UNITED STATES PATENT AND TRADEMARK OFFICE

10/537,249

Office Action Summary	Application No. 10/537,249	Applicant(s) NAKAMURA ET AL.	
	Examiner Dinesh Vesra	Art Unit 4136

DETAILED ACTION

Fig. 1

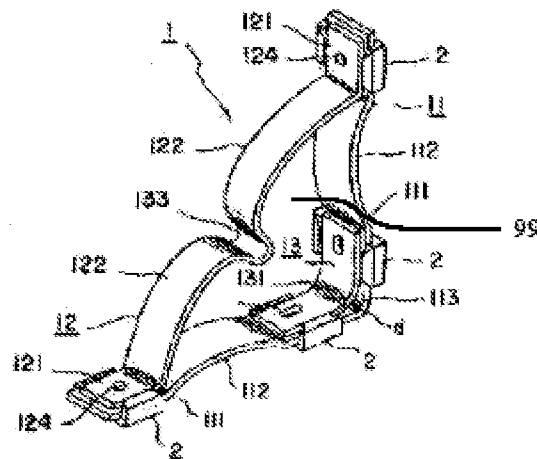
9. **Claims 1, 2, 5, 7, and 9 are rejected under 35 U.S.C. 103(a) as being unpatentable over Iwakawa (Japanese Patent Publication 2001-200590) in view of Okada et al. (US Patent 4,795,666).** With regards to claim 1, Iwakawa discloses a building reinforcing structure (Fig. 1) in which a reinforcing member (1) comprises a plurality of spring members (122, 112, 113, 131) and has a space formed between the spring members (99) and is bridged over (Fig. 4) and fixed (21) between one structural member (A-1) and another structural member (A-2). Iwakawa does not disclose a damper member and/or a synthetic resin foam in the space between the spring members, and a synthetic resin foam in the space enclosed by the structural members and the reinforcing member. Okada et al. discloses a reinforced structural member (Fig. 1) filled with a fiber reinforced material (12a) such as foam polyurethane (column 2, line 58). At the time of the invention, it would have been obvious to a person of ordinary skill in this art to use the foam polyurethane in the spaces mentioned above in Iwakawa in view of the teachings of Okada et al. The motivation for doing so would be to provide extra strength for the building reinforcing structure.

Regarding claim 2, the combination of Iwakawa and Okada et al. disclose the building reinforcing structure as set forth above, wherein the reinforcing member comprises a first spring member (122 - Fig. 1 - Iwakawa) and a second spring member (131), the first spring member comprises a plate spring (122) and the second spring member is formed as a leaf spring made by overlapping two plate springs (131, 113) and joining them with a retainer (2).

With respect to claim 5, the combination of Iwakawa and Okada et al. disclose the building reinforcing member which is bridged over (Fig. 4 - Iwakawa) and fixed (21) between one structural member (A-1) and another structural member (A-2) in a building, characterized by comprising a first spring member (122) and a second spring member (131) which have a curved shape (see Fig. 1 - Iwakawa), a space being formed between these spring members (99) and a damper member and/or synthetic resin foam (12a – Fig. 1 – Okada et al.) being provided in the space between these spring members.

With regards to claim 7, the combination of Iwakawa and Okada et al. disclose the building reinforcing member as set forth above in the discussion of claim 5, wherein the first spring member comprises a plate spring (122 – Fig. 1 - Iwakawa) and the second spring member is formed as a leaf spring made by overlapping two plate springs (131, 113) and joining them with a retainer (2).

With regards to claim 9, the combination of Iwakawa and Okada et al. disclose the building reinforcing member as set forth above in the discussion of claim 5, wherein the first spring member (122- Fig. 1 – Iwakawa) in the reinforcing member is formed to have a curve which protrudes away from the intersecting region of the structural members (see Fig. 4) and the second spring member is formed to have a curve which protrudes toward the intersecting region of the structural members (Fig. 4), to form a space between both spring members (99 - Fig. 1).
